Reigate & Banstead BOROUGH COUNCIL Banstead Horley Redhill Reigate	TO:	PLANNING COMMITTEE
	DATE:	28 September 2022
	REPORT OF:	Head of Planning
	AUTHOR:	Matthew Sheahan
	TELEPHONE:	01737 276514
	EMAIL:	matthew.sheahan@reigate-banstead.gov.uk
AGENDA ITEM:	9	WARD: SWH - South Park and Woodhatch

APPLICATION NUMBER:	22/01796/CON	VALID:	12/08/2022
APPLICANT:	Surrey County Council	AGENT:	n/a
LOCATION:	LAND AT WOODHATCH PLACE, 11 COCKSHOT HILL, REIGATE, SURREY, RH2 8EF		
DESCRIPTION:	The erection of a part one, part two and part three storey building to provide a 5-form entry junior school, with two all-weather sports pitches, a MUGA pitch, a hard play area with netball court, and provision of car parking spaces and provision of a new internal access road with a new egress point on to Cockshot Hill, with associated hard and soft landscaping and off-site highways works.		
All plans in this report have been reproduced, are not to scale, and are for illustrative purposes only. The original plans should be viewed /referenced for detail.

RECOMMENDED RESPONSE

Dwg Reference:
Proposed Elevations - Sheet 1 of 2

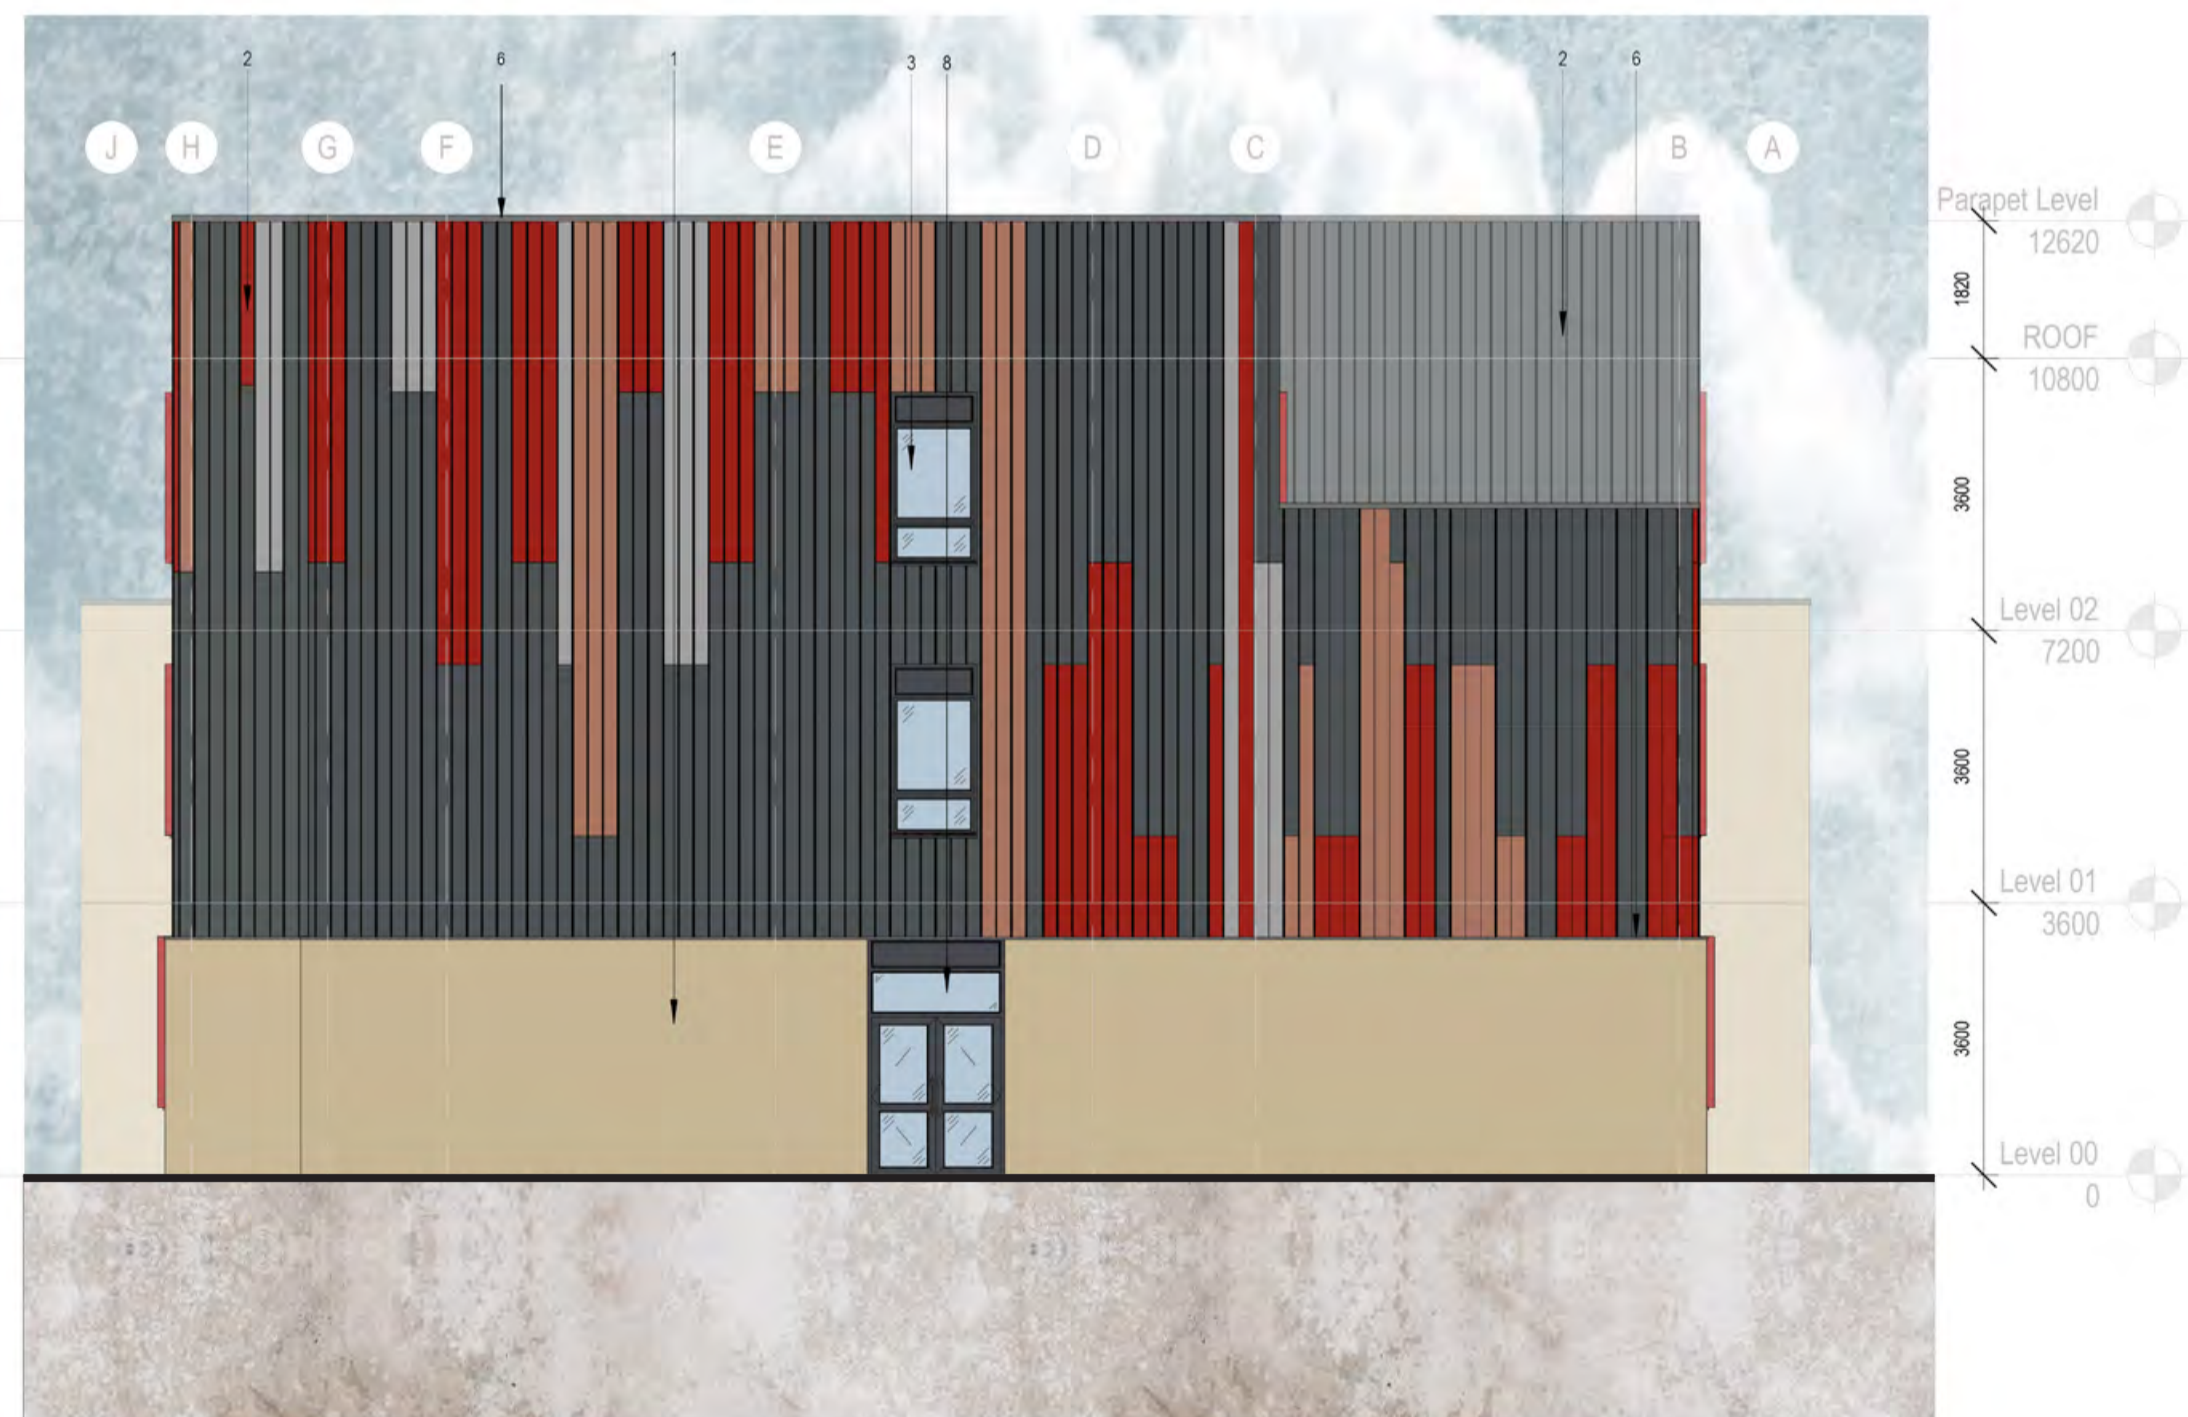
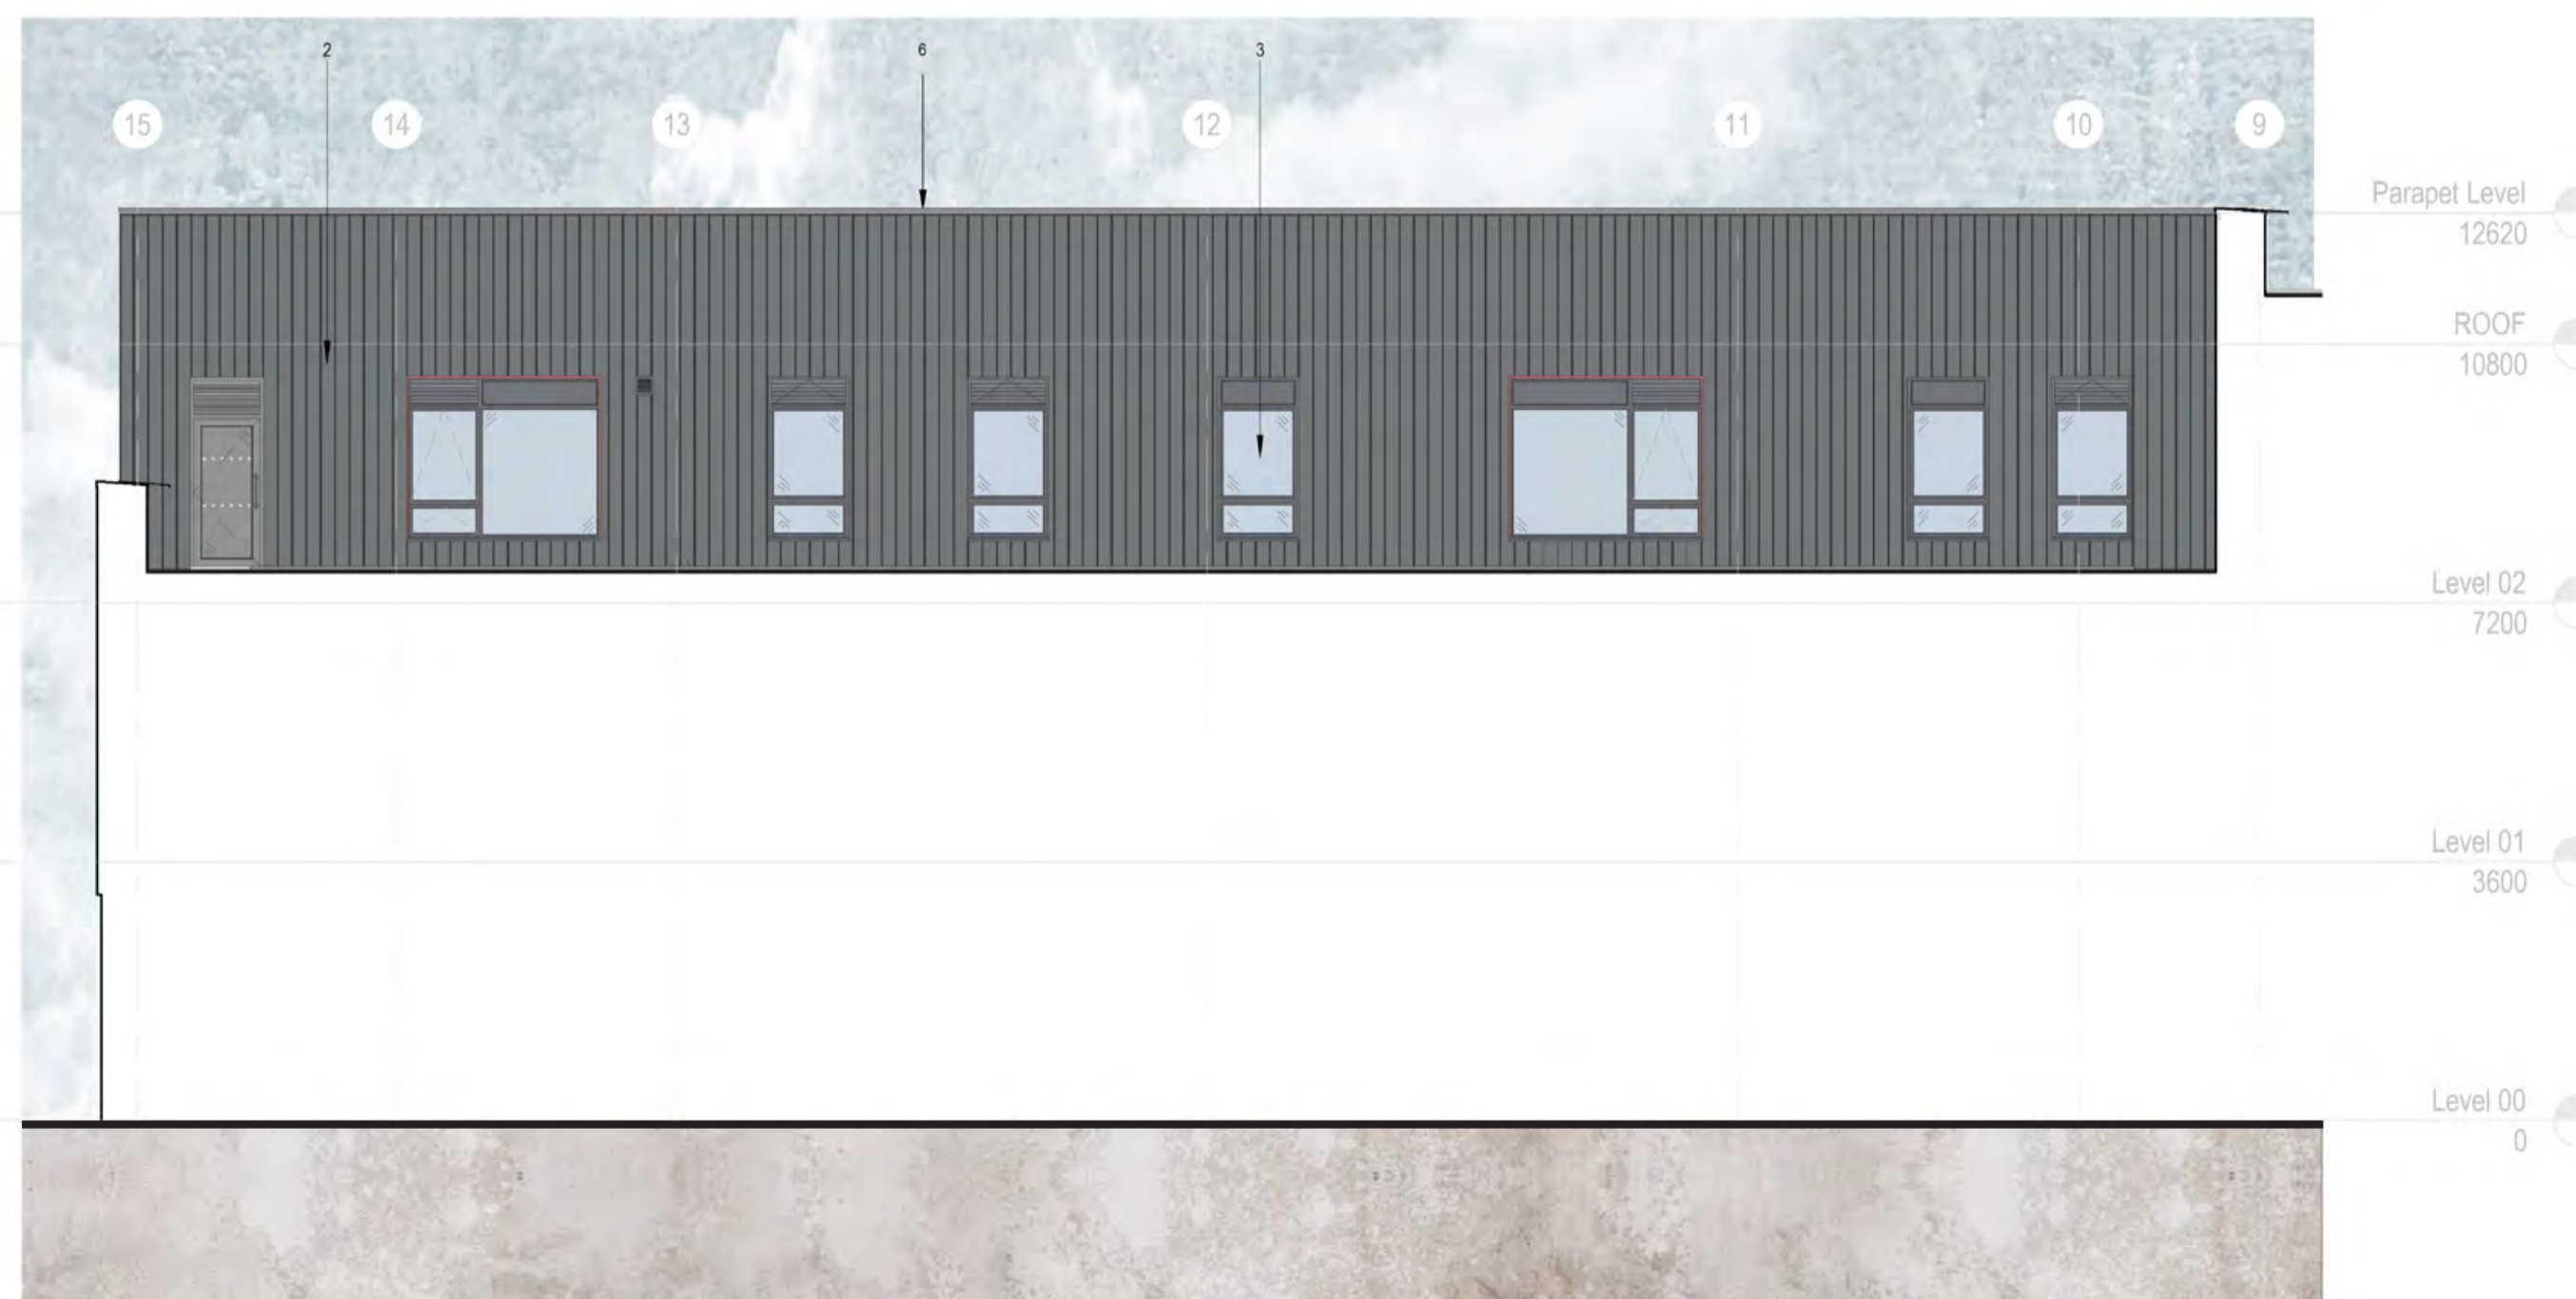
The footprint, obtrusive striped appearance and out of scale height of the new school and hardstandings will cause substantial harm. The 3 metre acoustic fence will harm the verdant appearance along Cockshot Hill (and could have been placed behind the shrubbery). It is contrary to the Local Distinctiveness SPD and associated DMP policy in terms of harm to the parkway/green corridor along Cockshot Hill by thinning out the shrubbery and hedge line and views through the gaps and above the tree and shrub line of the tall and obtrusive school building, as well as car parking, substation, (bin store if not successfully screened), fences, signs and hardstanding, particularly in winter views. The artificial pitches would be an alien feature in the parkland landscape and the inappropriate boundary screen of oddly straight lines of trees is at odds with the existing informal landscape and a large number of fences crisscrossing the historic informal parkland harming its appearance, including the lassoing of the eastern woodland.

- 3.2 The building would measure around 77 metres in length and 23 metres in width at its widest part and would have an overall height of 12.7 metres. The part 2 storey element would have an overall height of 7.63 metres. The school building would be finished in a buff brick for the 2 storey element and the ground floor of the 3-storey element with the upper floors of the 3 storey element being finished in cladding in the school colours of red and white with grey stripes.

- 5.20 The building extends some 77 metres in length and 23 metres in width at its widest part and would have an overall height of 12.7 metres. The part 2 storey element would have an overall height of 7.63 metres. The school building would be finished in a buff brick for the 2 storey element and the ground floor of the 3-storey element with the upper floors of the 3 storey element being finished in cladding in the school colours of red and white with grey stripes.

- 5.21 The height of the building is considered to be out of scale with the park and surrounding buildings, due to its 3 storey height and siting on a newly raised high bank which exacerbates longer views and impacts resulting in substantial harm within the park and setting of Woodhatch Place but also impact outside the park in terms harming the backdrop to listed buildings, and its visibility above the tree line, in gaps and in winter views, and harming the approach to the Reigate Conservation Area, as well as wider views from the south including the A217 and impacting on the appearance of the Greensand Ridge backdrop.
